802.3dj D2.2

Comment Resolution

Electrical Track

Figure 179A-3— Channel Min (TP0d-TP5d) at 53.125 GHz

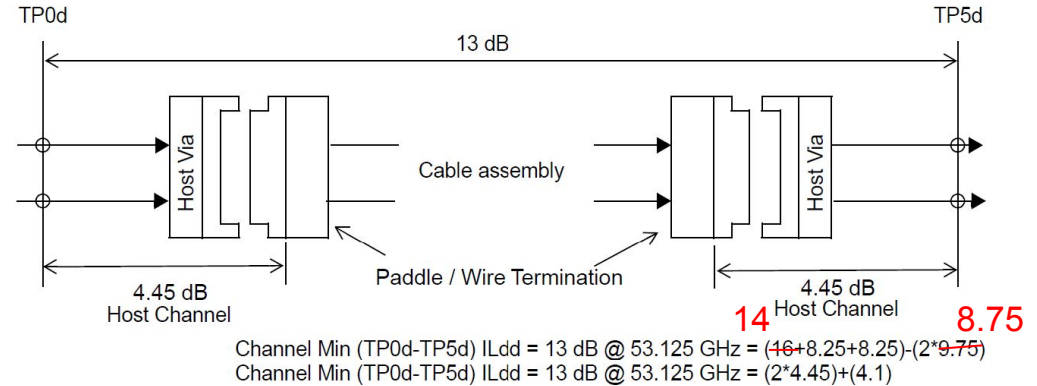
In D2P2, we do not have any tests for $ILdd_{Ch,min}$. In past projects, the minimum Host has been defined as the MCB, but that is not the case with 3dj.

The resolution for Comment #232 would changed the host channel allocation from 4.45 dB to 3.45 dB.

It is suggested to keep that value as 4.45 dB and instead make $ILdd_{CA,min}$ 14dB, as shown on the right.

Editor's recommendation: AIP (since no new data is presented) ;
Change $ILdd_{CA,min}$ to 14dB, and change appropriate values in 179, and 179A.
Implement with editorial license

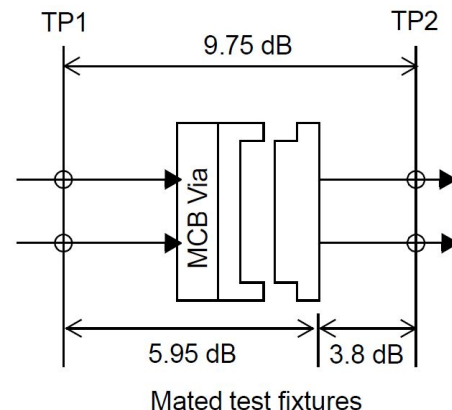
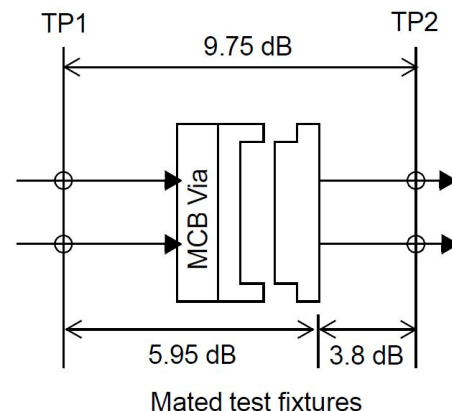
For the TP2/TP3 test fixture, the reference point is defined to be the "center of the edge connector pad". In 179B.3.1, it is stated that the reference point for the cable assembly test fixture is the "mating point of the MDI connector". There is a note in 179B.4.2 that states the reference insertion loss for the mated test fixture is the sum of the reference insertion losses for the TP2/TP3 test fixture and cable assembly test fixture. This suggests that the "center of the edge connector pad" and the "center of the edge connector pad" are the same reference point. If this is the case, then the same name/description should be used in both instances.

Call the reference point either "center of the edge connector pad" or "mating point of the MDI connector" consistently in both 179B.2.1 and 179B.3.1. Consider adding a note to Figure 179A-1 to describe the this reference point since the illustrations do not clearly show it.

The commenter points out a nomenclature conflict that must be remedied. The use of "mating point of the MDI connector" is most appropriate to apply to both instances. For completeness, the editorial team will prepare a detailed proposed response for the CRG to review.

Editor's recommendation:

Change the highlighted text in 179B.2.1 (TP2 or TP3 test fixture) to “mating point of the MDI connector”.

Figure 176D-4—Host compliance points

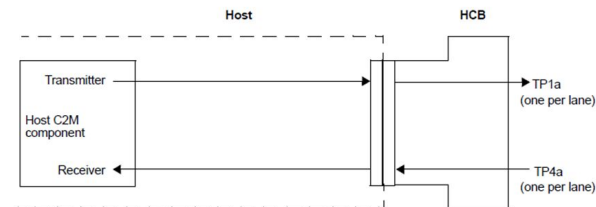
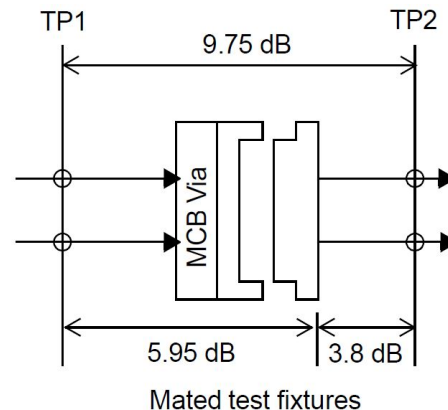
This is the normative clause that defines the TP2 or TP3 test fixtures. The test fixtures assume an MDI connector, a PCB board, and a coaxial connector enabling connection to test equipment, but that is not stated anywhere.

Editor's recommendation: Change the text in 179B.2 as shown below.

The TP2 or TP3 test fixture (also known as Host Compliance Board) is required for measuring the transmitter and receiver specifications at TP2 and TP3. The test fixture has an edge connector interface that is compatible with the appropriate MDI connector on the Host board, and provides a high-speed electrical path between the MDI connector and the coaxial connector that defines the TP2 or TP3 test point. The TP2 and TP3 test points are illustrated in Figure 179A-1.

The TP2 or TP3 test fixture is also used in AUI-C2M testing for host input and output compliance. The TP2 and TP3 test points correspond to the Annex 176D test points TP1a and TP4a, respectively. The TP1a and TP4a test points are illustrated in Figure 176D-4.

Figure 176D-5—Module compliance points

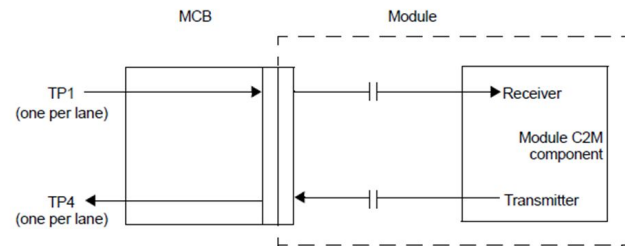
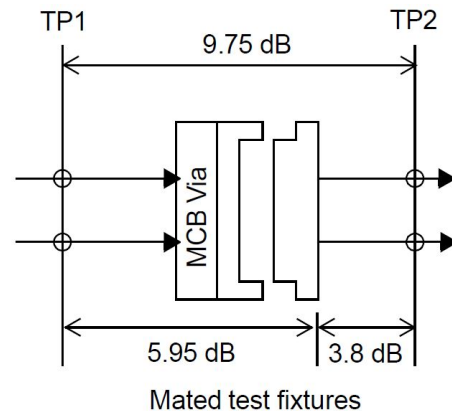
This is the normative clause that defines the Cable test fixtures. The test fixtures assume an MDI connector, a PCB board, and a coaxial connector enabling connection to test equipment, but that is not stated anywhere.

Editor's recommendation: Change the text in 179B.3 as shown below.

The cable assembly test fixture (also known as Module Compliance Board) is required for measuring the cable assembly specifications in 179.11 and the module specifications in Annex 176D at TP1 and TP4. The test fixture has an MDI connector, and provides a high-speed electrical path between the MDI connector and the coaxial connector that defines the TP1 or TP4 test point. The TP1 and TP4 test points are illustrated in Figure 179-2.

The cable assembly test fixture is also used in AUI-C2M testing for module input and output compliance. The TP1 and TP4 test points for AUI-C2M testing are illustrated in Figure 176D-5.
